## Product / Process Change Notification (PCN)

**PCN #:** PCN\_RfMK\_20190404

**Affected Series:** WE-MK A-Type; 7447840xxA – 744784110A

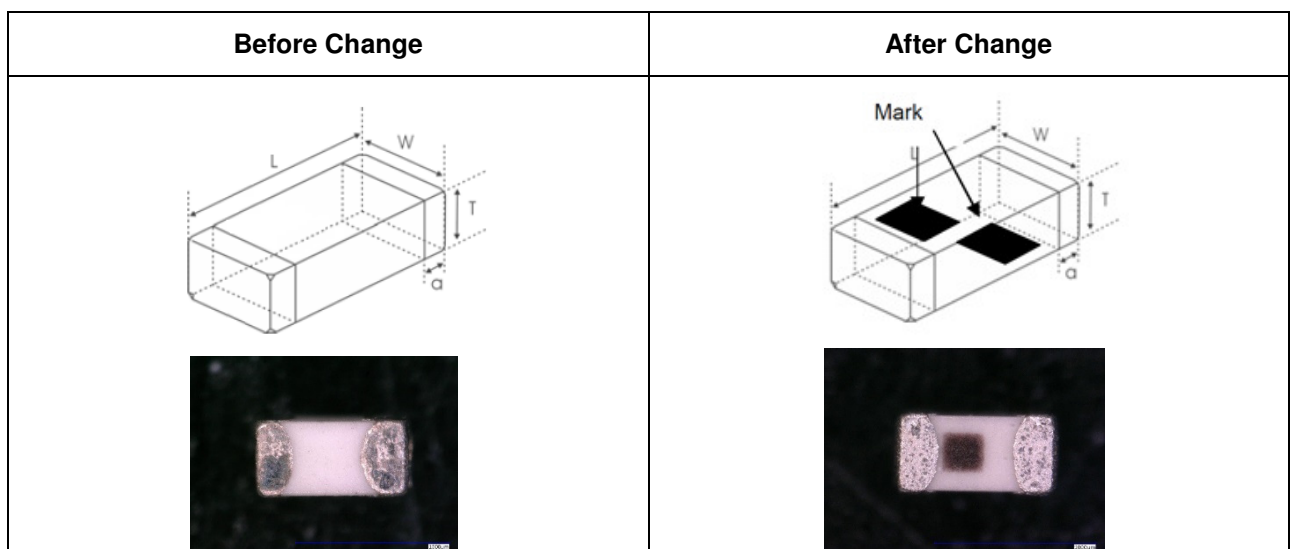
To meet current customer demands, Würth Elektronik will add a marking on the described multilayer inductors (i.e. WE-MK A-Type of size 0402 whose inductance value is  $\leq 10nH$ ).

All products with date code 2019-02-18 or later, will be affected by this change.

There will be no change in form, fit, function, quality or reliability of the product.

After the change the corresponding inductors will include double side marking as below:

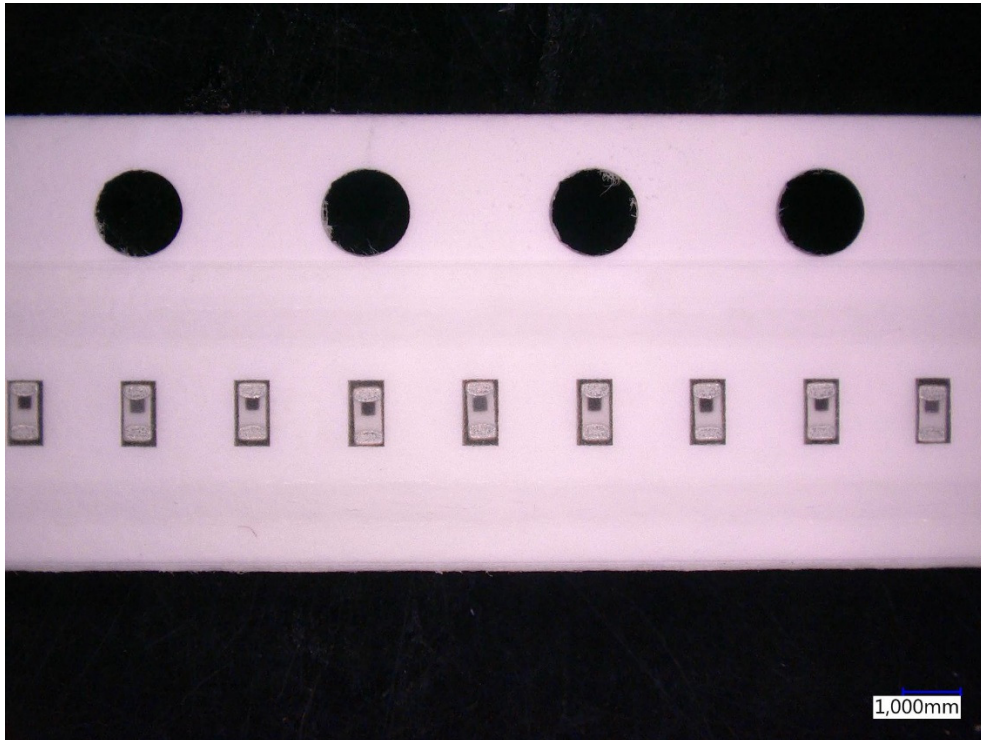
The marking has the purpose of showing the internal structure of the coil. The coil's plane is parallel to plane containing the markings. Therefore, the orientation of the coil inside the inductor is fixed.

CT Picture of the inductors inside the tape:

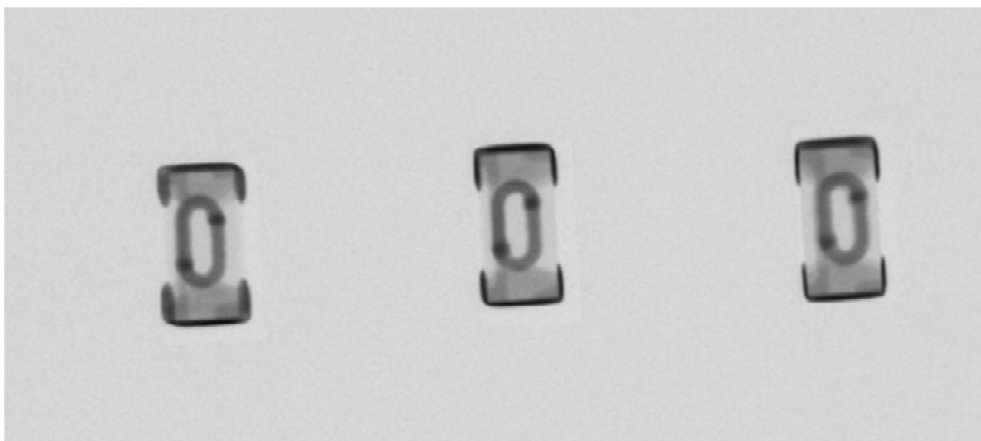
Marking orientation of the inductors inside the tape:
